CITY OF
ST. AUGUSTINE
EST. 1565
CORRIDOR REVIEW COMMITTEE

- a) HP2022-0089

Matthews Design Group, LLC - Applicant
Deacon Transportation, INC. - Owner
32 San Marco Avenue

DSEC HP2022-0089
32 San Marco Avenue
January 5, 2023

LANDSCAPE PLAN
32 SAN MARCO HTA PARKING
CITY OF ST. AUGUSTINE
PREPARED FOR
HISTORIC TOURS OF AMERICA

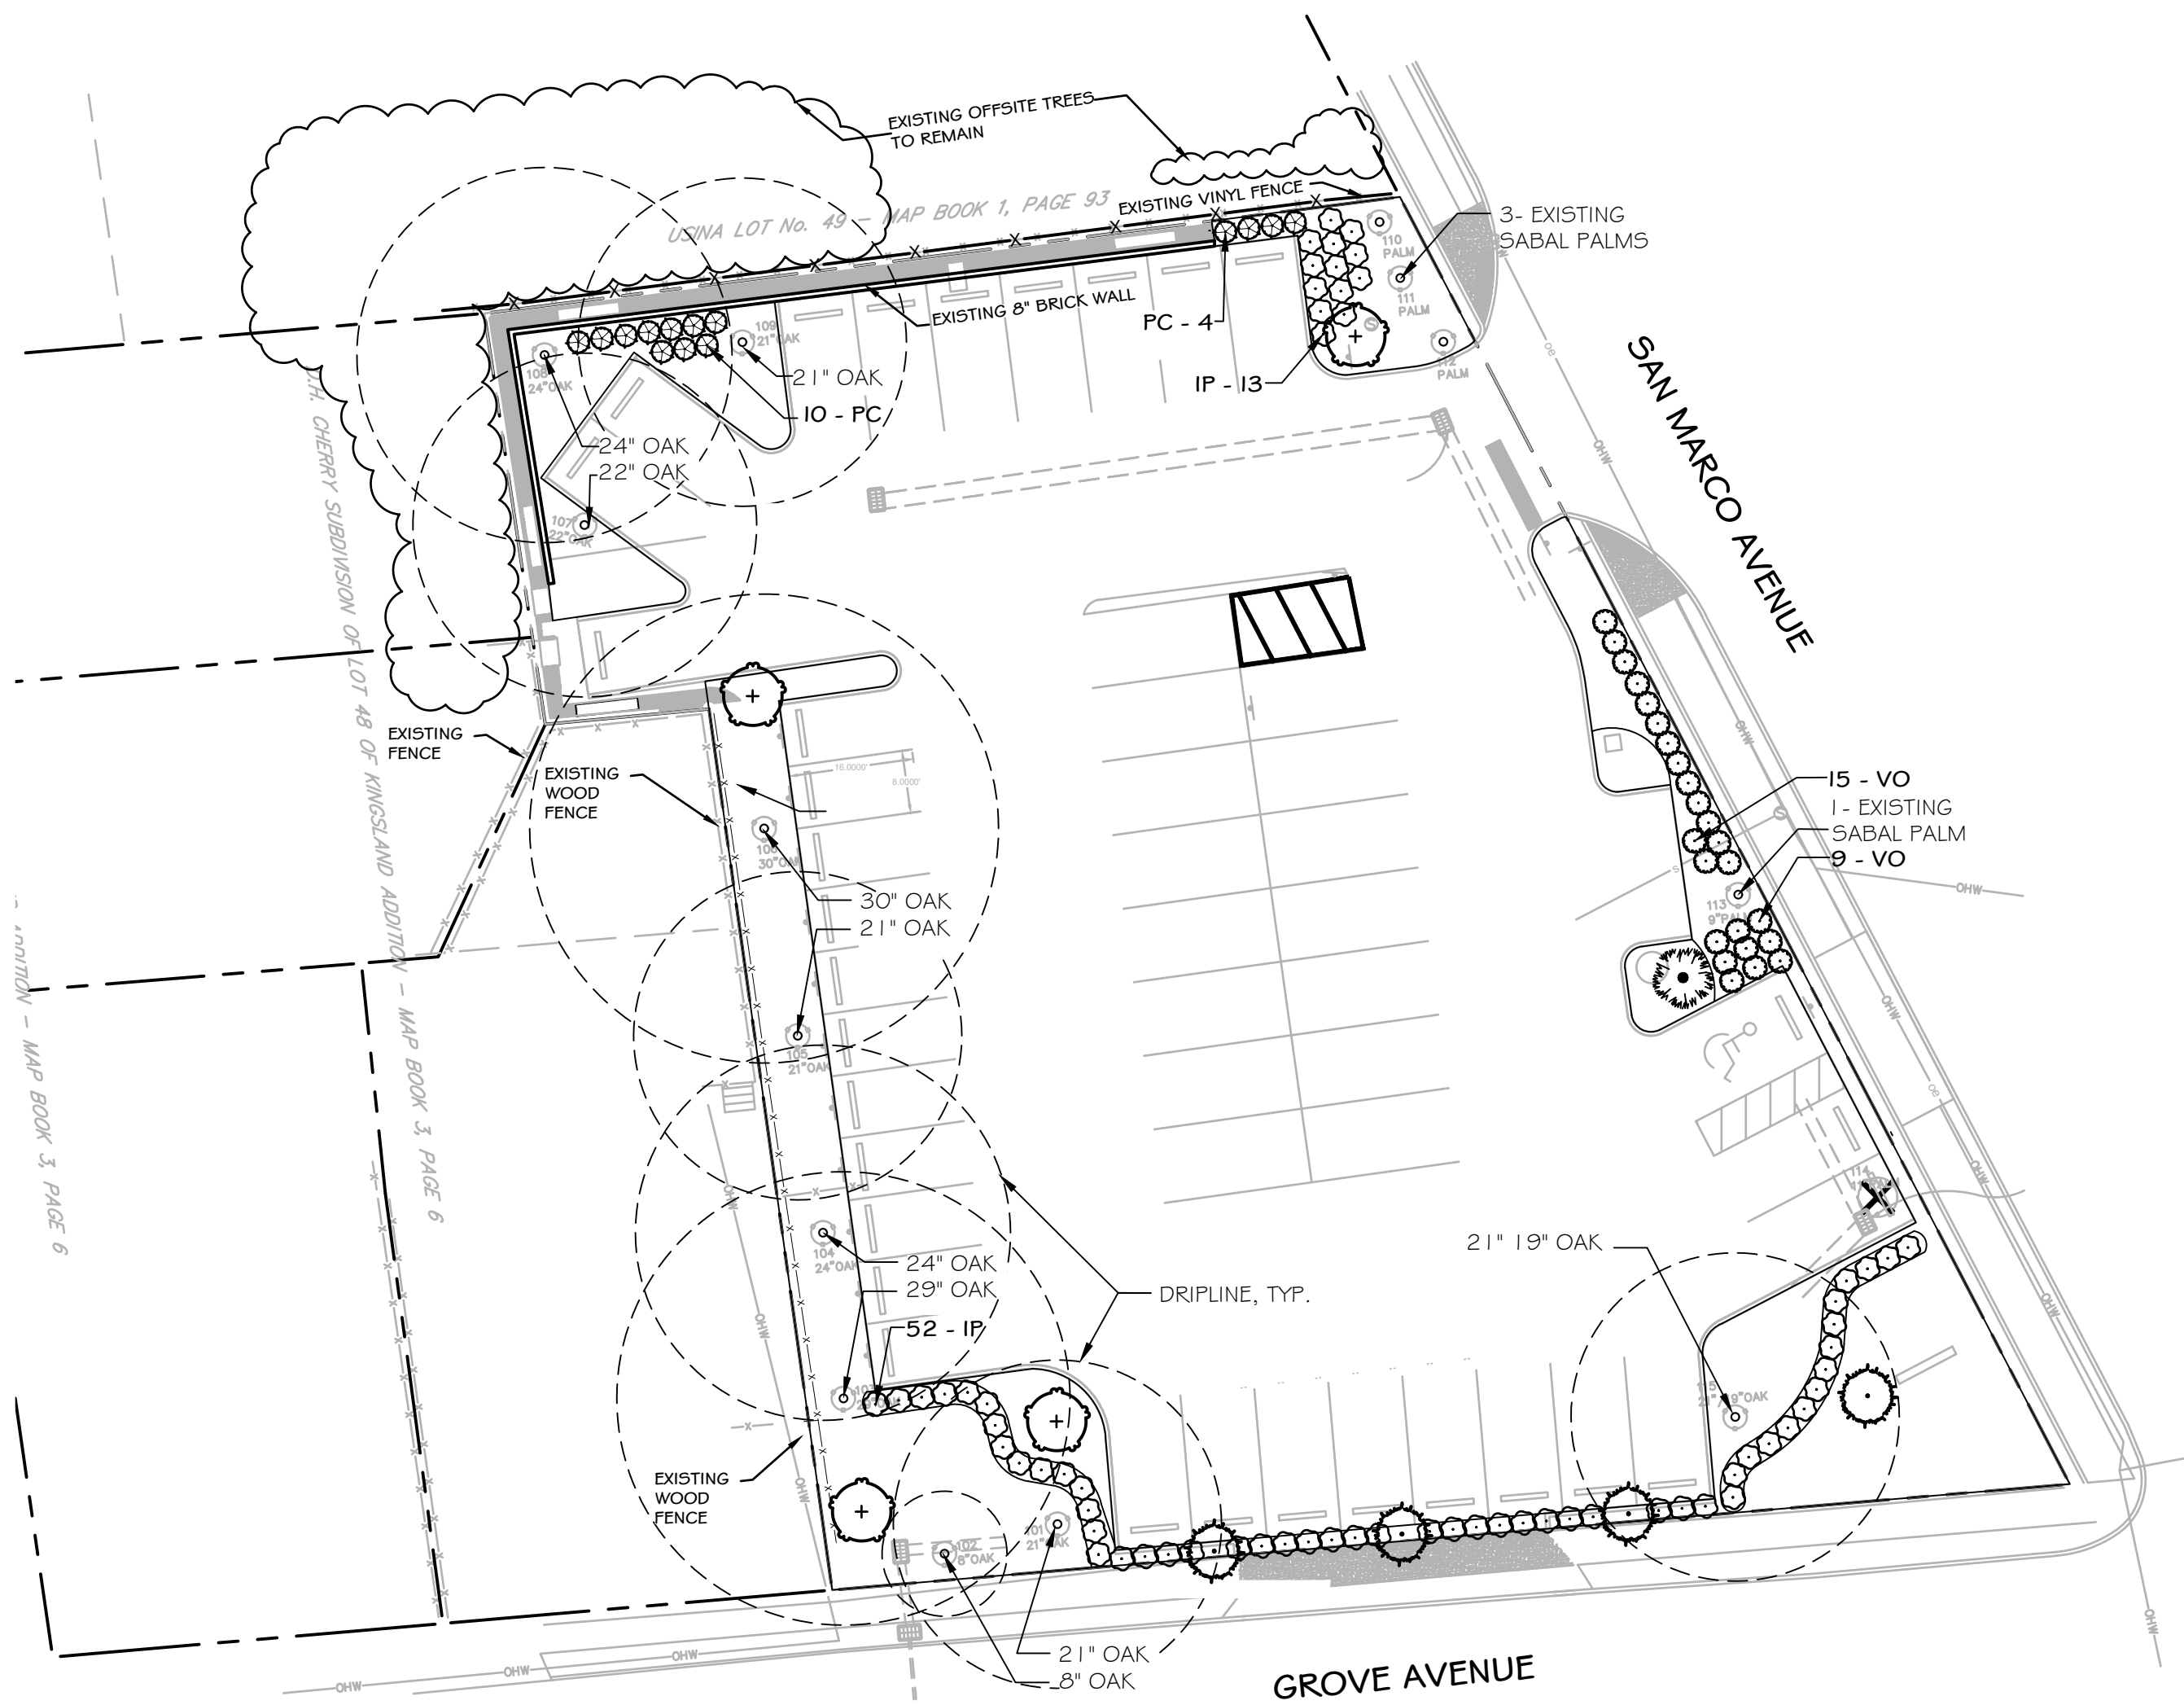
1. **4.5.1 Pedestrian Access:** There is no clear indication of pedestrian access from the sidewalk to the lot on the site plan or updated landscape plan. FDOT comments provided by the applicant voice a similar concern. The applicant should clearly indicate where they intend to provide pedestrian access to the right-of-way.

2. **4.5.3 (b) Re: Parking Placement:** A street wall or fence is generally required to screen parking areas located directly on San Marco Avenue. Based upon the pre-existing nature of the parking area and the reduction of other non-conforming properties of the existing lot, the proposed landscape will satisfy the screening requirements if the applicant can prove that the landscape buffer plantings are uninterrupted along San Marco Avenue. An appropriate-style picket fence should be installed in buffer yard areas that cannot support appropriate plantings.

3. **5.6 (1) Re: Landscaping:** For every 5,000 feet of pavement there should be approximate 5% (250sf) of greenspace which generally consists of planting islands within the paved parking area. The applicant has provided for this requirement with some landscape "peninsulas" and the CRC should determine whether this is sufficient to meet the requirements. This language mirrors requirements of the Land Development Code.

ELECTRICAL SITE PLAN
SCALE: 1" = 10'-0"

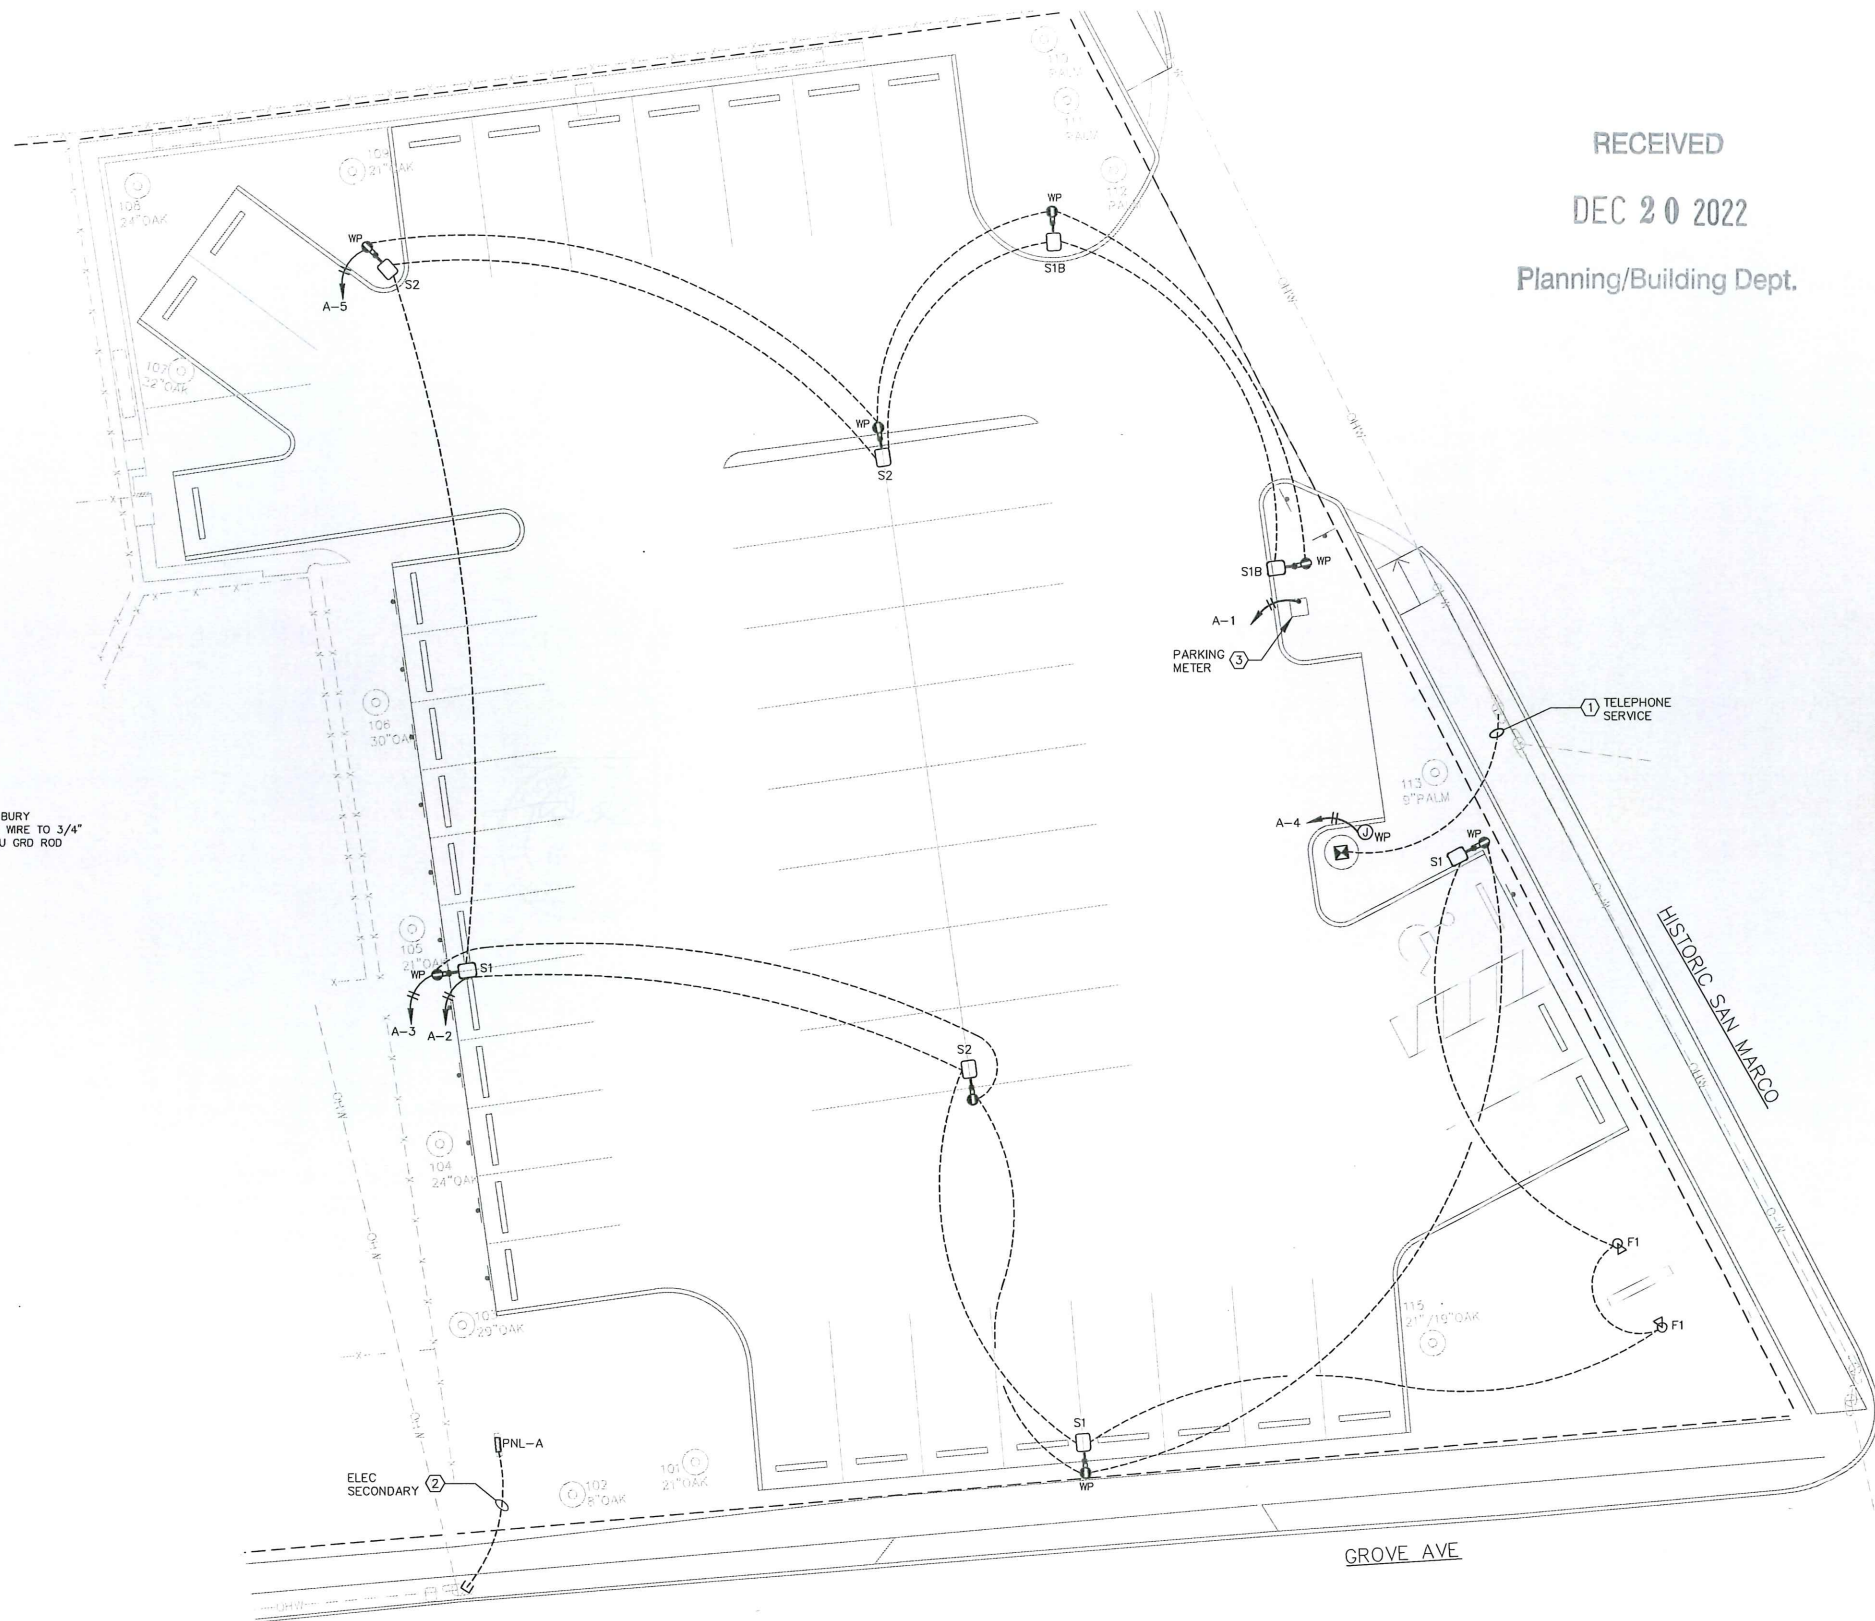
4. Landscaping requirements not mentioned above, including number of plantings and type of plants, have been sufficiently met within the application.
5. Requirements for site lighting are met in relation to required footcandles; however, it would benefit the board and staff to have a photo showing what the lighting fixture(s) will look like because the drawings do not give a clear indication of whether the lighting source will be visible.

**HISTORIC DISTRICT
PARKING**

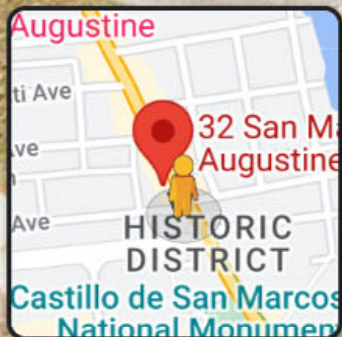
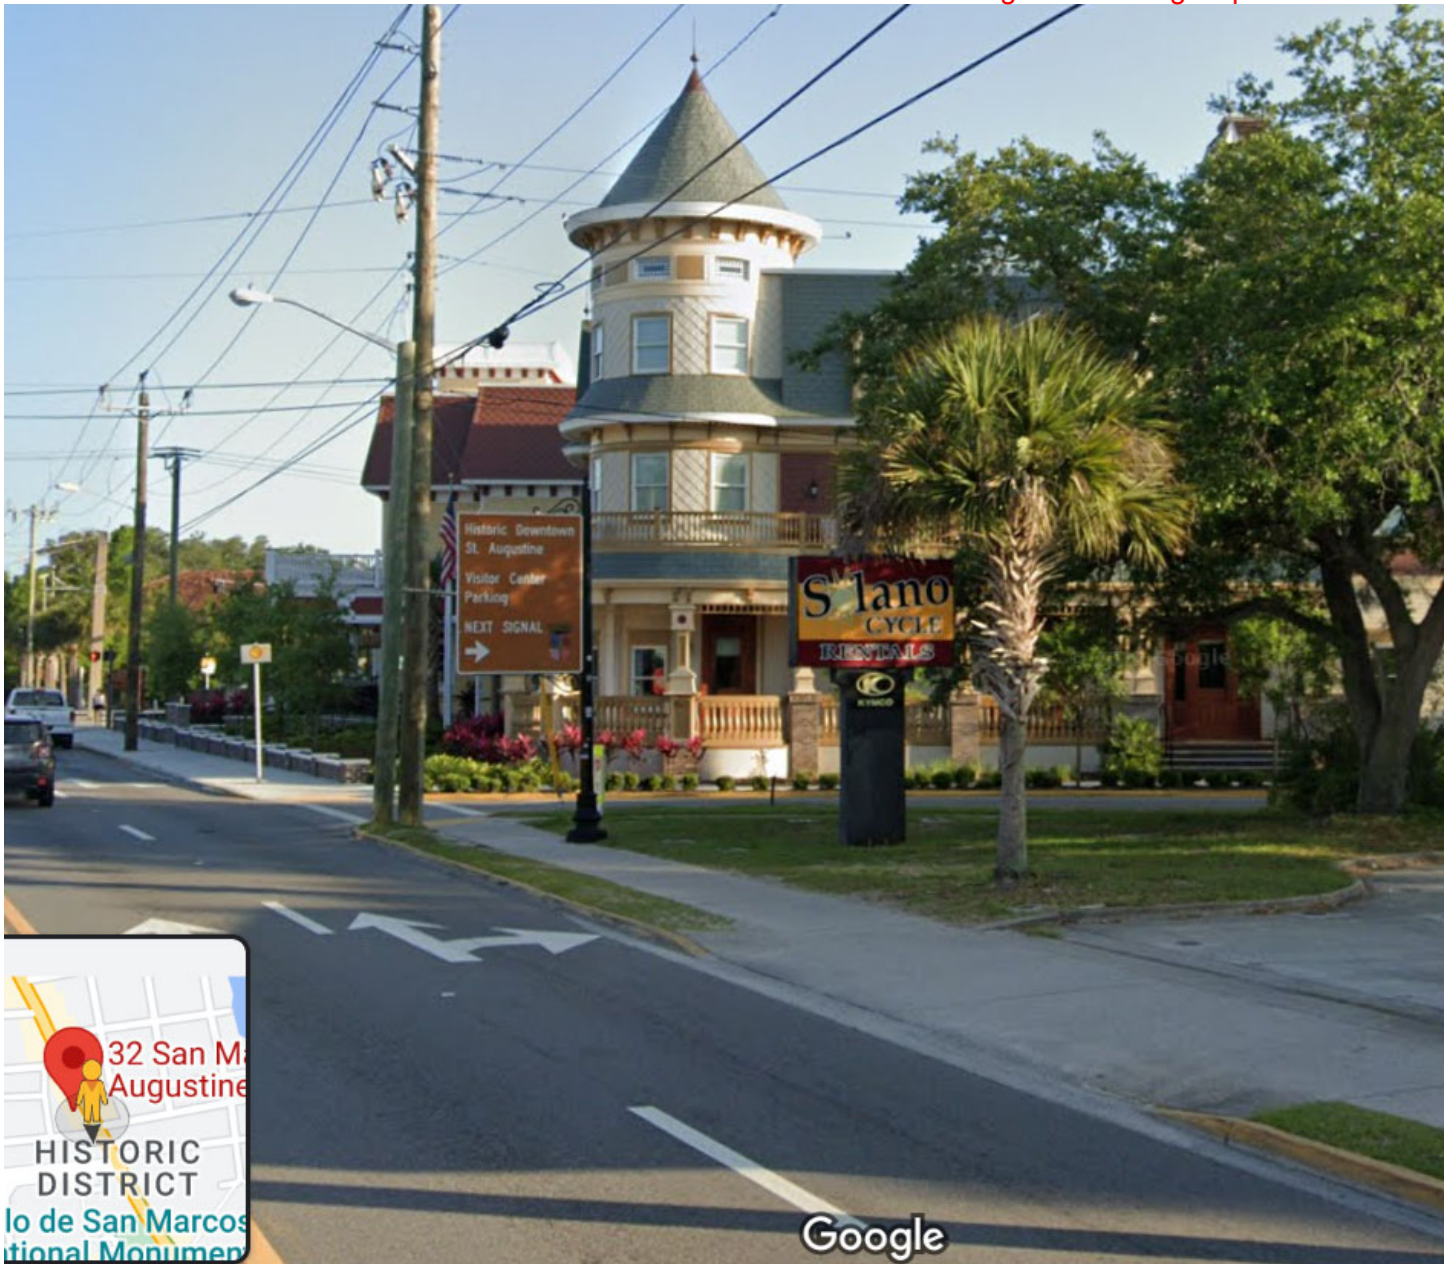
4. **Appendix C – Colors:** While the background of the proposed freestanding sign design is Peristyle Brass, a pre-approved color, the dark blue lettering is not a pre-approved color and requires approval from the CRC for its use. Pre-approved blue colors include Bunglehouse Blue (a dark, muted blue with a hint of green) and Bathe Blue (a light, almost pastel, blue). There is staff concern, based upon language in the Sign Code, that the proposed sign may too closely mimic existing city and state installed directional signs and the applicant should provide evidence that this is not the case, or provide an alternative design that is less like existing traffic signs.

It is my understanding that you would be able to reface the existing Solano Cycles sign for the parking area with review and approval of a sign permit. Is the existing sign internally illuminated? Due to the extensive alterations to the site and the change in businesses, the sign may require being externally illuminated moving forward because internally illuminated signs are not allowed in the Entry Corridor per section 6.3 of the Design Standards (p. 63).

Please find attached our new submittal with the Peristyle Brass color. Thank you for sending the color palette and suggested color. It is a two-sided existing sign we wish to reface. Non-interior illumination (exterior illuminated with lights per the electric plan submitted and attached for reference). Pictures below of existing sign.
